Docket Number:	08-AFC-09C
Project Title:	Palmdale Energy Project (Formerly Palmdale Hybrid Power Plant) - Compliance
TN #:	208550
Document Title:	Palmdale Energy LLC's Supplemental Response to CEC Staff Data Request 62
Description:	N/A
Filer:	Marie Fleming
Organization:	DayZen LLC
Submitter Role:	Applicant Representative
Submission Date:	1/22/2016 8:35:38 AM
Docketed Date:	1/22/2016

WORKER SAFETY AND FIRE PROTECTION (62)

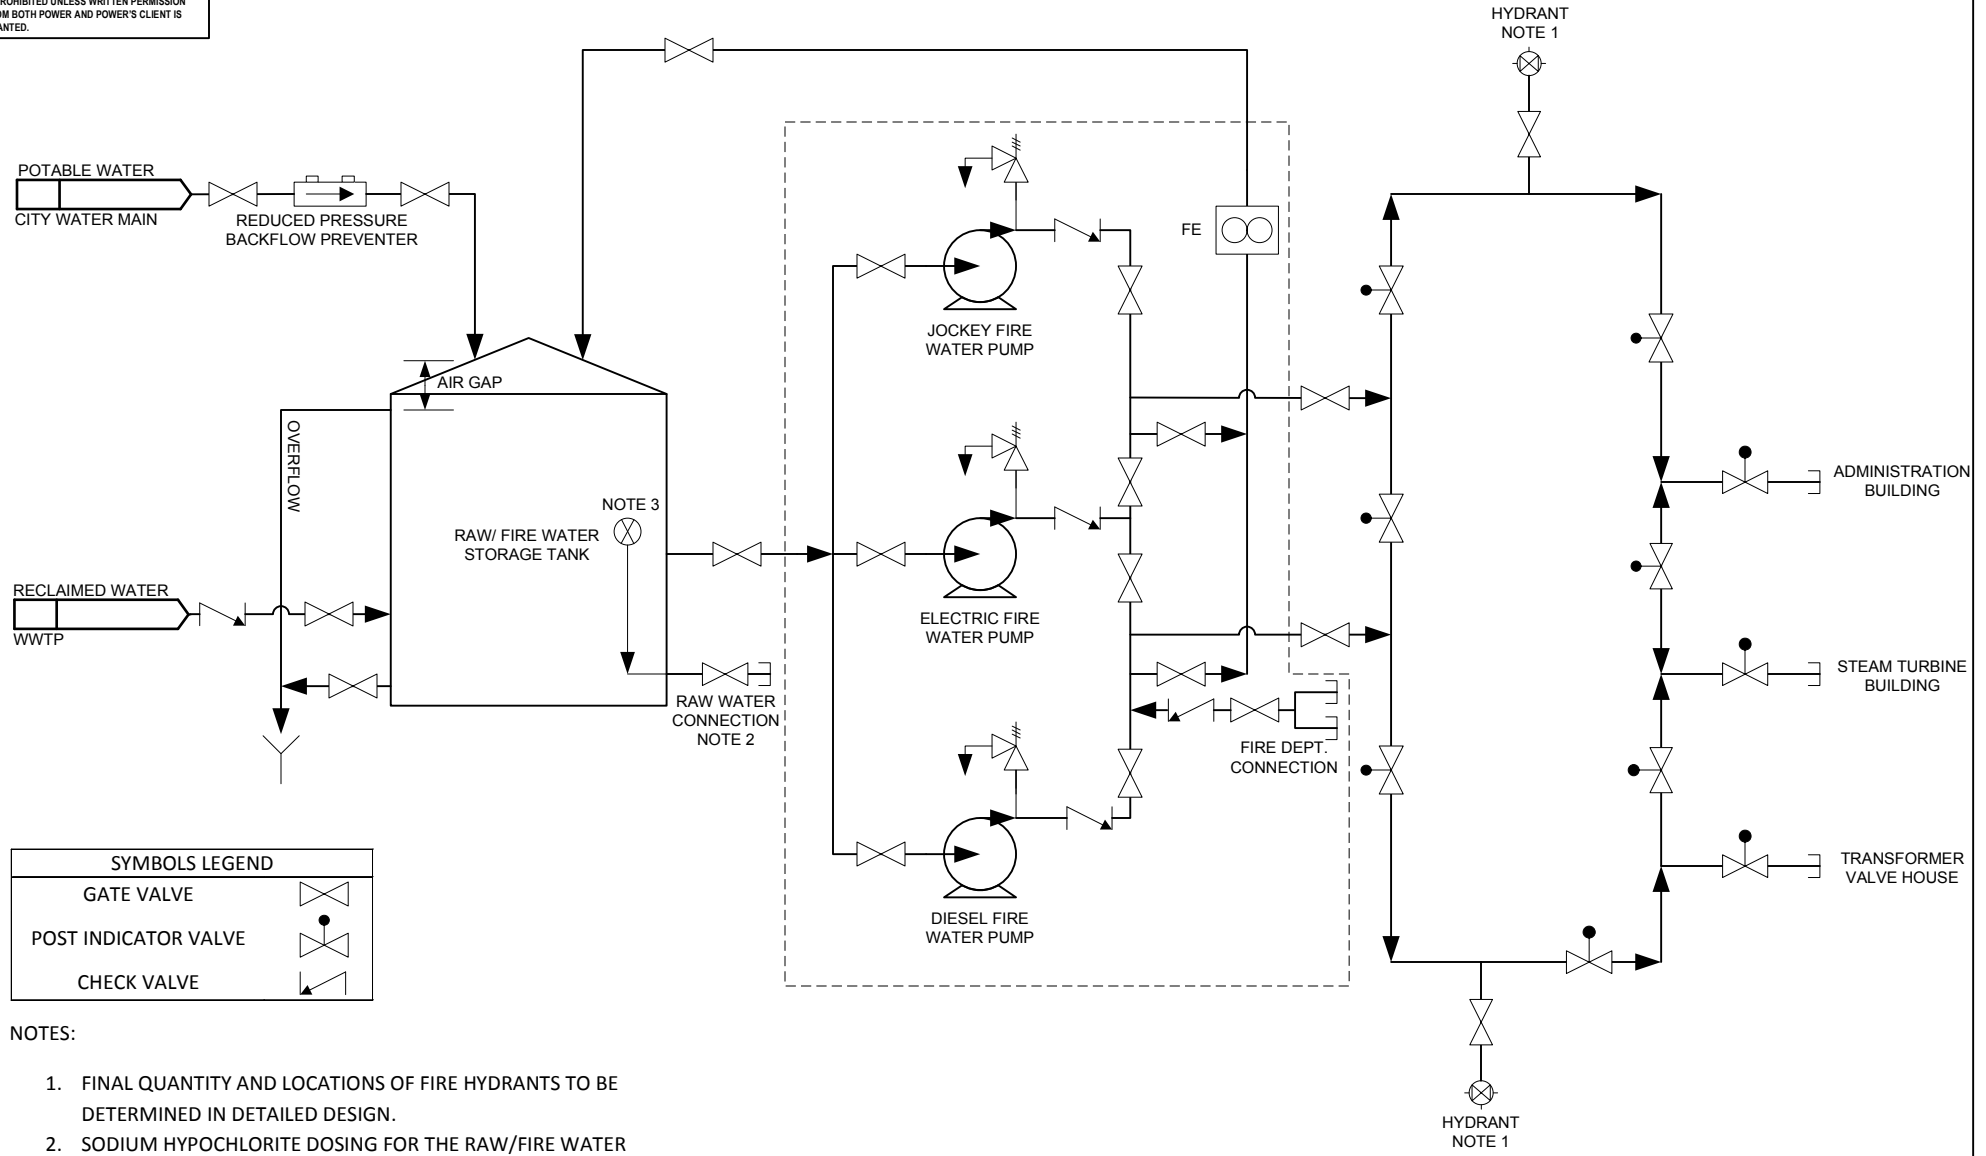
Please describe the backup water supply to the fire suppression system when the dedicated 200,000 gallon on-site reserve is exhausted. If the back-up supply is the potable water main from the LA county Waterworks District #40 pipeline, please describe the engineering system that will be used to connect to this source and the cross-connection prevention methods to be used.

Potable water from the Los Angeles County Waterworks District #40 will be used as the backup source of fire water. The use of potable water requires backflow prevention measures to protect potable water sources from contamination. The potable water pipe supplying water to the Raw/Fire Water Storage Tank will be equipped with a Reduced Pressure Principle Backflow Prevention Device that is UL listed, FM approved, and meets the requirements of NSF Standard 61 and AWWA C506-78(R83). In addition, the potable water will be fed into the top of the Raw/Fire Water Storage tank to provide an air gap separation between the point of potable water entry into the tank and the overflow piping for the tank. The fire protection system process flow diagram provided as Figure DR-62 depicts the location of the backflow prevention device and air gap.
